Department of Planning and Zoning

TO: Design Advisory Board
FROM: Scott Gustin
DATE: February 25, 2014
RE: 14-0038CA, 395 Manhattan Drive

Request: Demolish existing residential structure and construct new duplex.

NORTH FACE

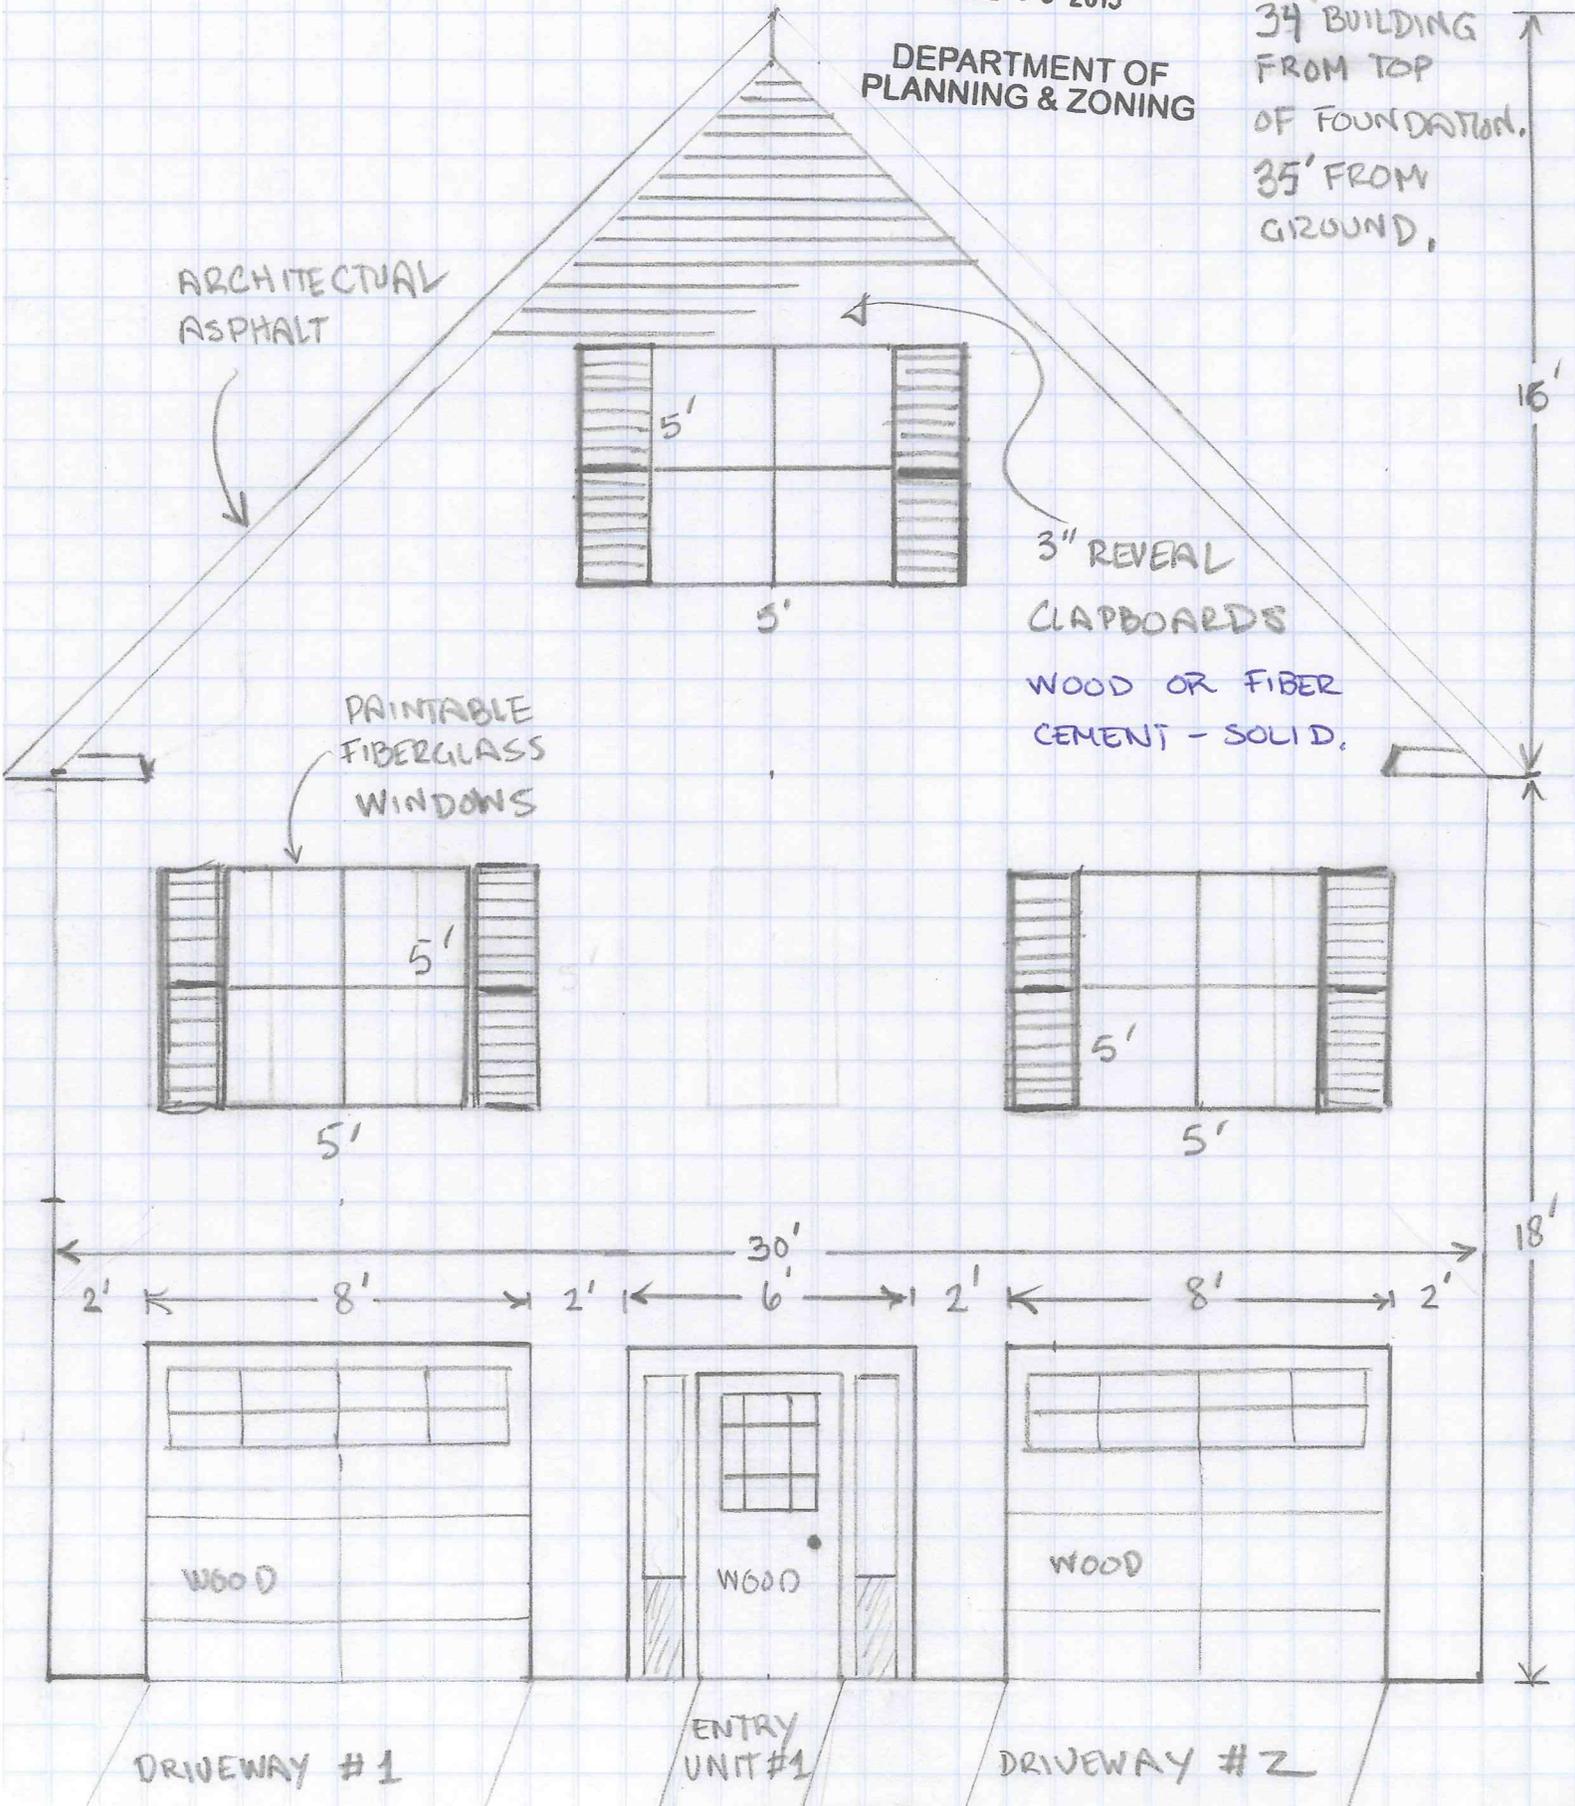
The front façade includes two garage entries. These entries are flush with the front face of the building and must be revised so that they are set behind the pedestrian entrance into the building. No specific setback distance for the garage doors is required; however, there must be a break in the building plane with the pedestrian entrance more prominent than the garage entries. A slightly projecting front entry may be the most appropriate option in light of the overall building design. The garage doors comprise some 53% of the total front façade width. This width is permissible so long as they are under a single roofline and wholly integrated into the overall building design and there is living space above them. Such is the case here.

The proposed home is located close to the sidewalk as neighboring buildings are. Its front entrance is clearly discernible. As noted above, some variety should be incorporated into the front façade. The central pedestrian entry should project out, and variety should be incorporated into the building materials palate. As stated before, trim details are also needed.

The new building will be subject to current egress requirements. The basement is proposed to be finished, and egress will be provided by way of egress windows. No egress windows for the basement are evident in the building elevations and must be depicted. Building entries should be illuminated. Lighting details are needed as noted above.

1. A revised front entry that projects in front of the adjacent garage doors.
2. A landscaping plan that depicts generally what new plantings are proposed where. A rain garden is encouraged for receiving and infiltrating roof runoff.
3. Outdoor lighting fixture locations and cut sheets.
4. Windows depicted on the building elevations that match the windows in the cut sheets provided. Basement egress windows must be depicted in the elevation drawings. Elevation drawings must show details accurately.
5. Trim materials noted on the elevation drawings.
6. Incorporate of some variation in cladding on the front façade to differentiate the upper floor from the bottom two floors (i.e. shingles vs. clapboards).

Pella® Impervia® Single Hung Window

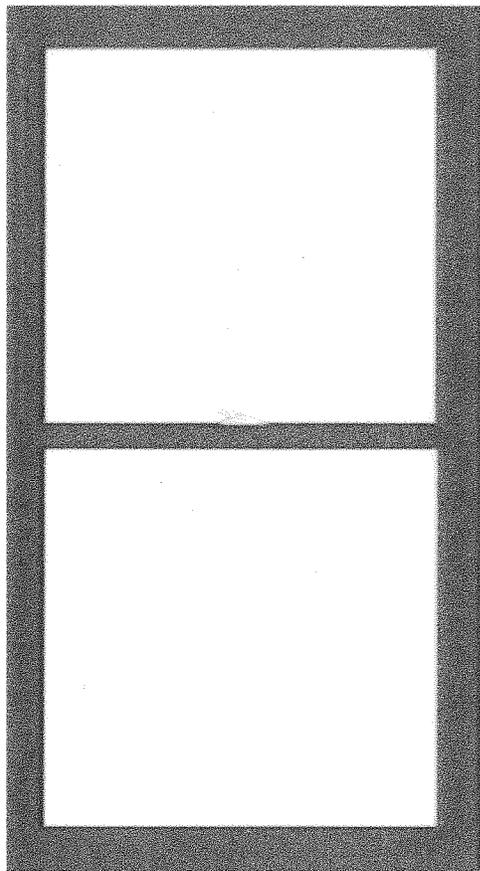
Fenestration details provided are very limited. The newly provided window specification sheet continues to depict 1-over-1 double hung units whereas the elevation drawings suggest large 2-over-2 casement or awning units. Perhaps they are side-by-side double hung units.

Clarification is needed. Trim and casing details are also lacking. Building entries are similarly lacking in detail. A front door is proposed, and what seem to be rear sliding doors are also proposed. Improved elevation drawings that depict all trim details are needed.
